**Environmental Assessment of  
Ground Water Compliance at the  
Shiprock Uranium Mill Tailings Site**

**Final**

**September 2001**

Prepared by  
U.S. Department of Energy  
Grand Junction Office  
Grand Junction, Colorado

Figure 24. Sample Locations for the Salt Deposit Study

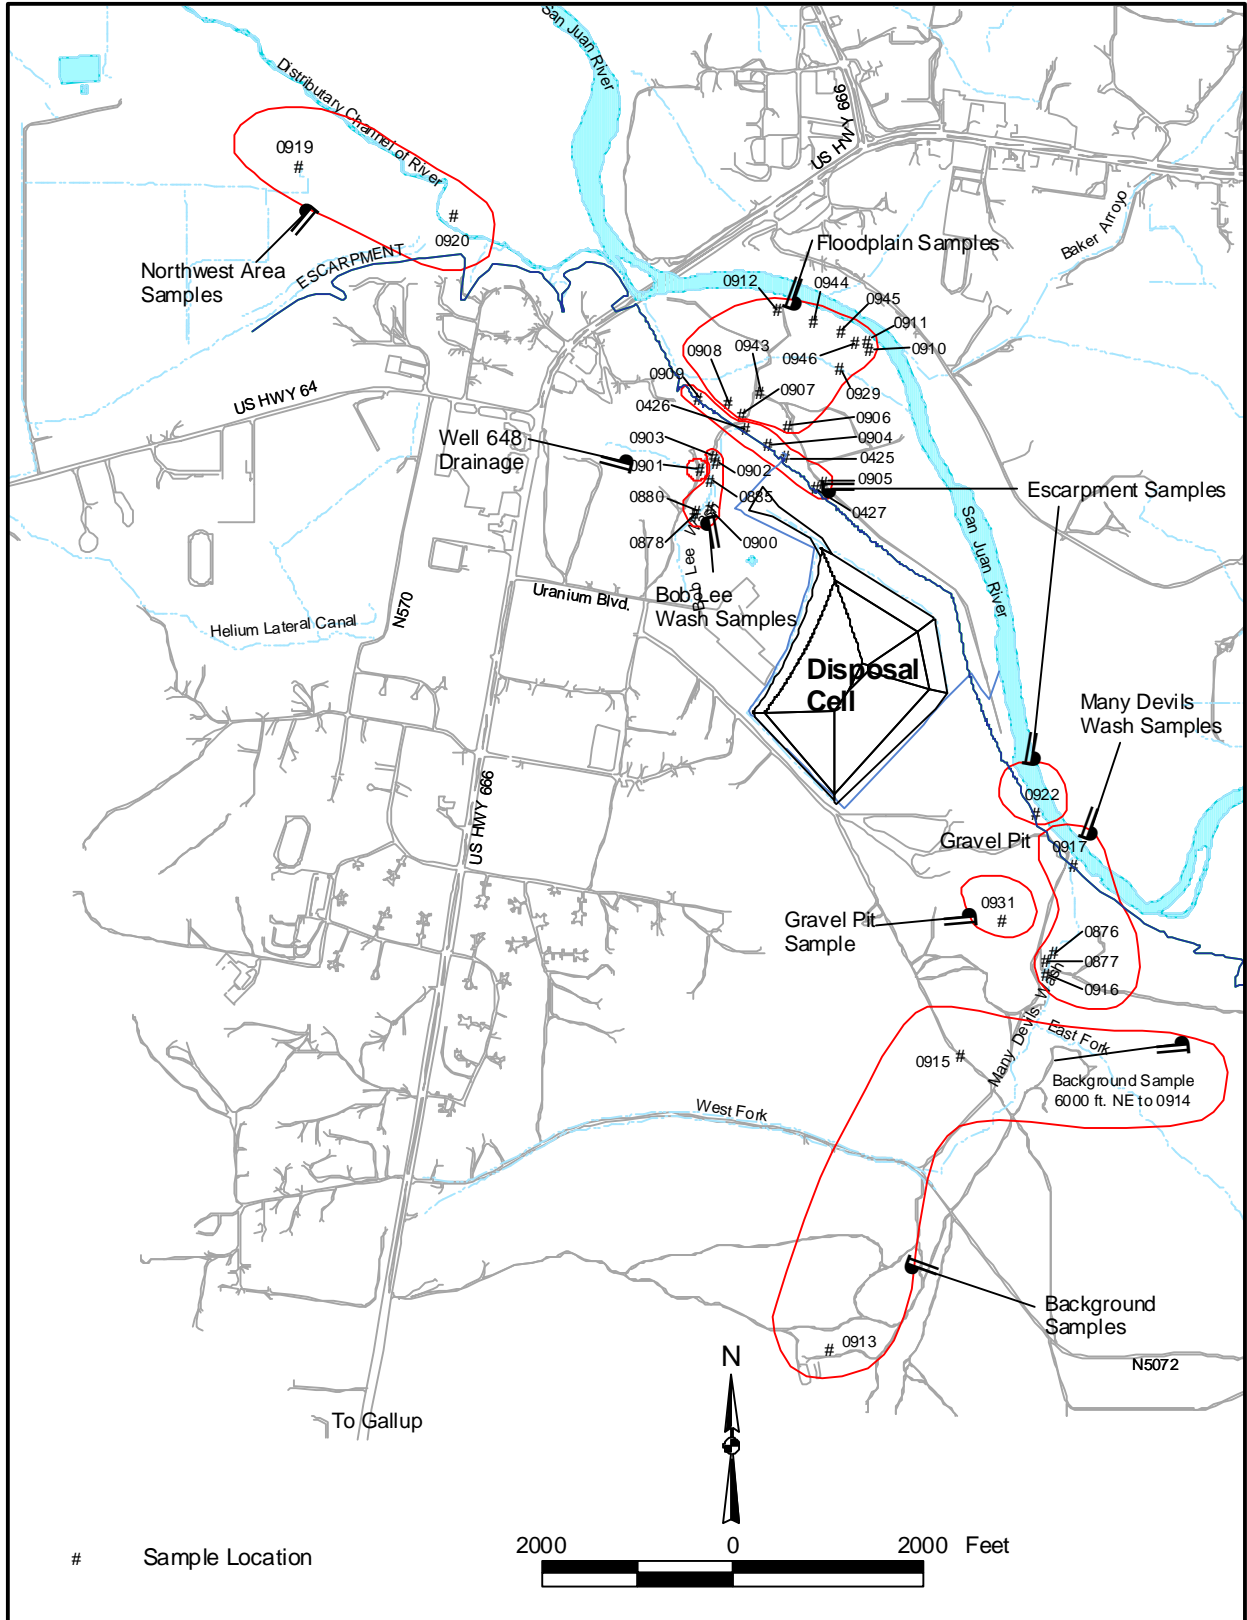
110	p.59, Figure 24: Remove the text "US HWY 66" on the northern highway.	S	A	Figure 24 will be revised.
111	p.80: "Dr. Steve Semken" should probably be written as "Steve Semken, Ph.D."	S	A	Revision will be made.
<b><i>U.S. Fish and Wildlife Service comments received June 14, 2001</i></b>				
112	The Service cannot concur with DOE's conclusion that the proposed remedial actions "may affect but are not likely to adversely affect" federally listed species.	R	NC	DOE acknowledges the Navajo Fish and Wildlife and U.S. Fish and Wildlife Service concerns and is committed to working with both agencies to address protection of endangered species. DOE believes that remediation will have a positive effect on endangered species.
113	The Service would like to meet...to continue informal consultation on the project.	R	NC	Since the receipt of comments on the EA, DOE has communicated with the USFWS and Navajo Fish and Wildlife on several issues that still require resolution. DOE has agreed to continue consultation as the project progresses and has committed to determining if additional short-term actions in specific areas require mitigation beyond that already completed as interim actions.
